Table 3.2-14

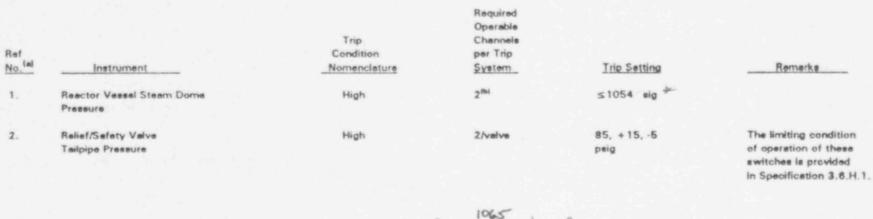
* The unit may operate with a setpoint of < 1065 psig for a commulative duration of 35 days for power uprate test purposes.
